# Technical Service Bulletin No. 34

**Created by: Lab.gruppen AB Service Department**

**Reference no: OVP on SP100F-SP130F**

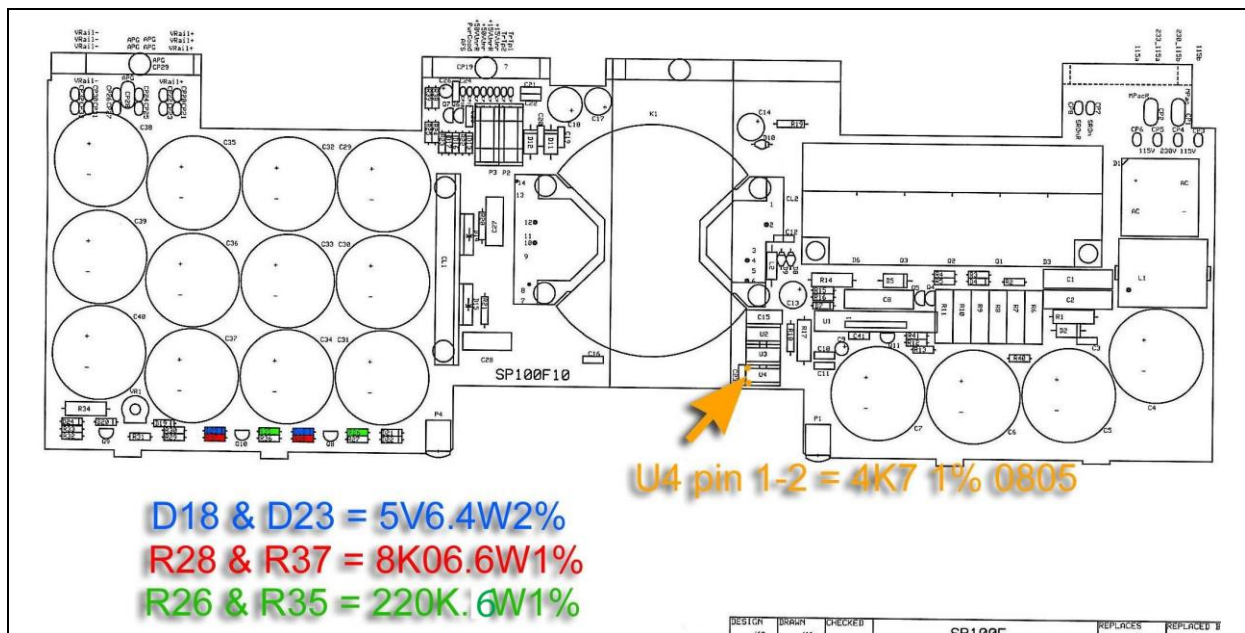
Update the OVP circuit

Instruction approved for	
PCB Revision	BOM Version
SP100FXXX-XXX	All

Part No.	Description	Amount	Info	Pos
5V6.4W2%	Diode Zener 5V6 .4W 2%	2		D18, D23
220K.6W1%	Resistor Metal Film 220k .7W 1%	2		R26, R35
8K06.6W1%	Resistor Metal Film 8k06 .6W 1%	2		R28, R37
4K7.125W1% 0805	4K7.125W1%0805	1		U4 pin 1-2
SSP100F10d-FXX	Sticker SSP100F10d-FXX	1

1.	Note! 4K7.125W1% resistor is mounted on solder side		
----	---	--	--

between pin 1 & 2 .		
---------------------	--	--

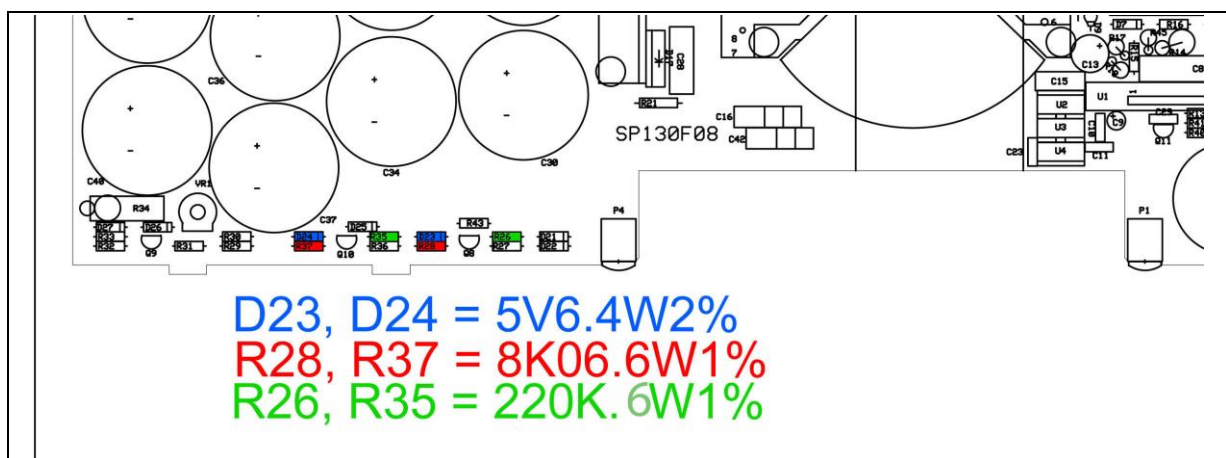
Instruction approved for		
PCB Revision	F-version	BOM version
SP130F02	F01, F03, F04, F05	All
SP130F04	F01, F03, F04, F05	All
SP130F08	F01, F03, F04, F05	All
SP130F10	F01, F03, F04, F05	a,b

Part No.	Description	Amount	Info	Pos
5V6.4W2%	Diode Zener 5V6 .4W 2%	2		D23, D24
220K.6W1%	Resistor Metal Film 220k .7W 1%	2		R26, R35
8K06.6W1%	Resistor Metal Film 8k06 .6W 1%	2	160V	R28, R37
SP130F10c-F01	Smps 13kW flyback Rev10,vers.c, Final Assembly type 01	1

2.	Mount components according to picture.		
----	--	--	--

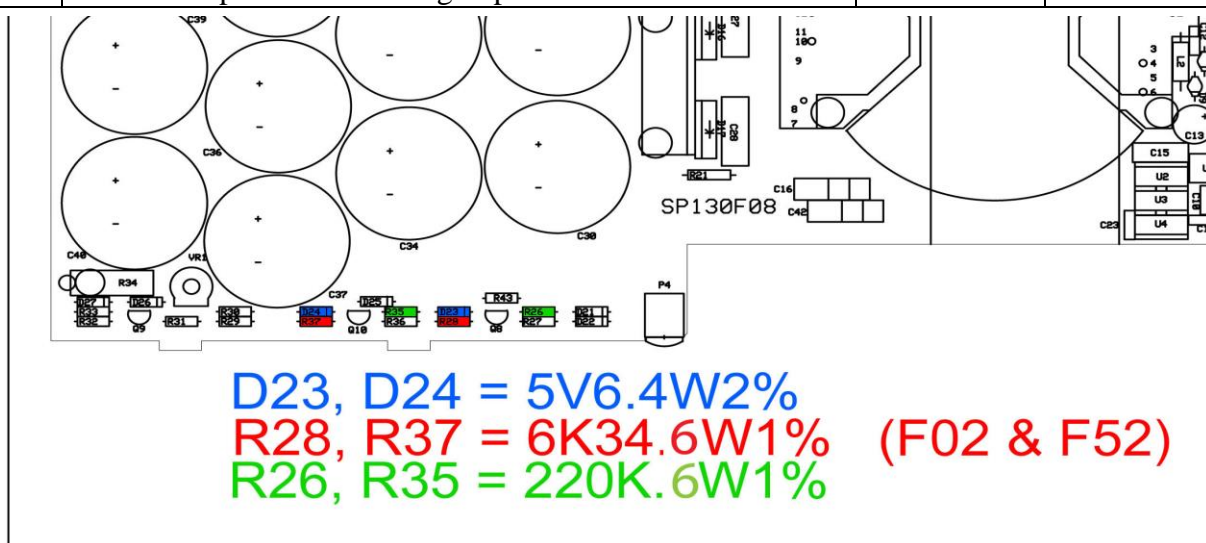
Instruction approved for		
PCB Revision	F-version	BOM Version
SP130F02	F02	All
SP130F04	F02	All
SP130F08	F02	All
SP130F10	F02	a,b

Part No.	Description	Amount	Info	Pos
5V6.4W2%	Diode Zener 5V6 .4W 2%	2		D23, D24
220K.6W1%	Resistor Metal Film 220k .6W 1%	2		R26, R35
6K34.6W1%	Resistor Metal Film 6k34 .6W 1%	2	200V	R28, R37
SSP130F08g-FXX	Sticker SP130F08g-FXX	1

3. Mount components according to picture.
